## **BOYKIN PLANTATION SUBDIVISION**

APPLICATION NUMBER 9 DATE November 1, 2012

APPLICANT Boykin Plantation Subdivision

REQUEST Subdivision

# DETAIL SITE PLAN

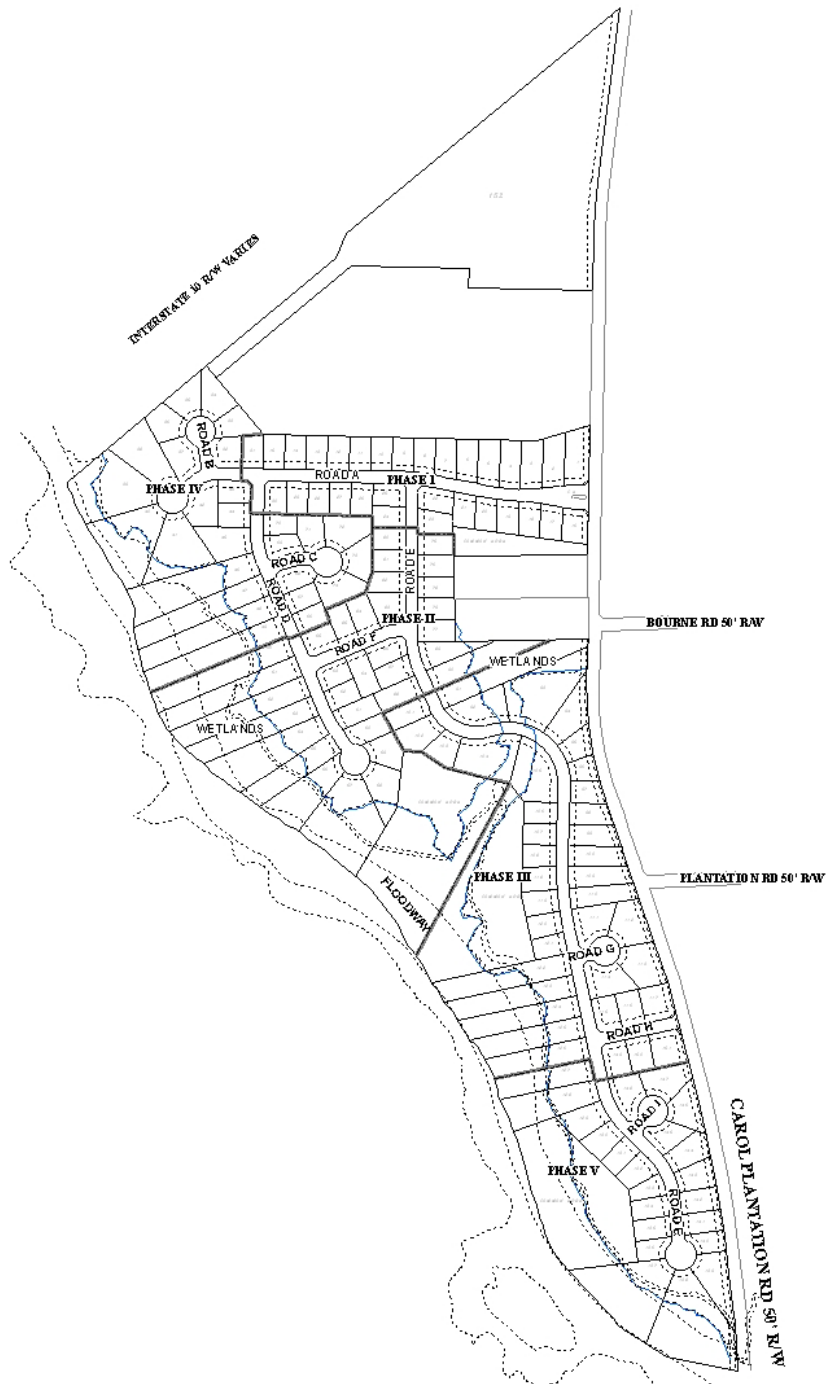
The site will be composed of streets connecting multiple cul-de-sacs. The proposed Road "D" cul-de-sac street appears to exceed the Section V.B.6. recommended 600-foot maximum length, in that it will be approximately 840 feet long. All other cul-de-sacs are less than the maximum length.

All of the proposed cul-de-sacs appear to be drawn with a diameter of approximately 98 feet, which is less than the 120 foot diameter required by Section V.B.14. of the Subdivision

Regulations. The plat should be revised to depict the correct required minimum diameter, and lot sizes revised as necessary.

The 25-foot setback line and notation is not depicted on the preliminary plat. The plat should be revised to depict and note the 25-foot minimum building setback line as required by Section V.D.9. of the Subdivision Regulations, and should also be depicted from both street frontages for those lots with double-frontage.

No phases are depicted on the plat. If the subdivision will be developed in phases, those phases should be depicted on the plat.

Common areas are proposed for the site. All common areas should be labeled, and notes should be placed on the preliminary plat stating that maintenance shall be the responsibility of the property owners.

Wetlands and floodplains exist on the site, in association with Rabbit Creek. The plat depicts the floodway and delineated wetlands, but does not depict the AE or X-shaded zones. The plat should be revised to depict all necessary flood zones, and any finished floor elevations that may be required by Mobile County Engineering. A note should also be placed on the plat stating that development of the site must be undertaken in compliance with all local, state and federal laws as they relate to wetlands and floodplains.

It appears that the proposed subdivision does not include the entirety of parcel R023308332000001. The plat should be revised to include the entire parcel.

Finally, the plat should be printed at a standard engineering scale, rather than the 1 inch = 140 feet scale as submitted.

*All lots within each phase meet minimum size and width requirements, however, several lots appear to exceed the width to depth ratio specified in Section V.D.3. of the Subdivision Regulations. As many of these lots are deep due to adjacent wetlands and floodplains, it is recommended that Section V.D.3. be waived, however, future subdivision of lots exceeding the 3.5 width to depth ratio should be prohibited unless the property has adequate additional frontage on a public street (as in the case for Lot 93 in proposed Phase III).*

*Lot 152, due to its long frontage along Carol Plantation Road, should be limited to a maximum of three (3) curb-cuts, with the size, design and location to be approved by Mobile County Engineering, and to conform with AASHTO standards.*

*The site abuts Interstate 10, a US highway. Access to Interstate 10 should be denied for the entirety of the development.*

*A revised plat was submitted reflecting all requested changes. The remainder of parcel R023308332000001. is now proposed Lot 152, with approximately 1025 feet of frontage onto Carol Plantation Road.*

*The revised plat depicts the 151-lot portion of the subdivision to be developed in five phases, ranging from 22 to 39 lots per phase. In order for any approval of the subdivision to remain*

*Based on the revised plat, and with a waiver of Section V.D.3. of the Subdivision Regulations, the application is recommended for Tentative Approval, subject to the following conditions:*

- 1) Placement of a note on the final plat stating that Lots 1-151 are denied direct access to Carol Plantation Road, with each lot limited to one curb-cut to a street being constructed as part of the subdivision, with the size, design and location to be approved by Mobile County Engineering and to comply with AASHTO standards;*

- 2) Placement of a note on the final plat stating that Lot 152 is limited to three (3) curb-cuts onto Carol Plantation Road with the size, design and location to be approved by Mobile County Engineering and to comply with AASHTO standards;*

- 3) Placement of a note on the final plat stating that all lots are denied access to Interstate 10;*
- 4) Construction and paving in concrete or asphalt of all roads to Mobile County Engineering standards, and acceptance thereof, prior to recording of any phase of the subdivision;*

- 5) No future subdivision of any lot exceeding the width to depth ratio of Section V.D.3. of the Subdivision Regulations, unless the lots will have adequate frontage on a public street;*
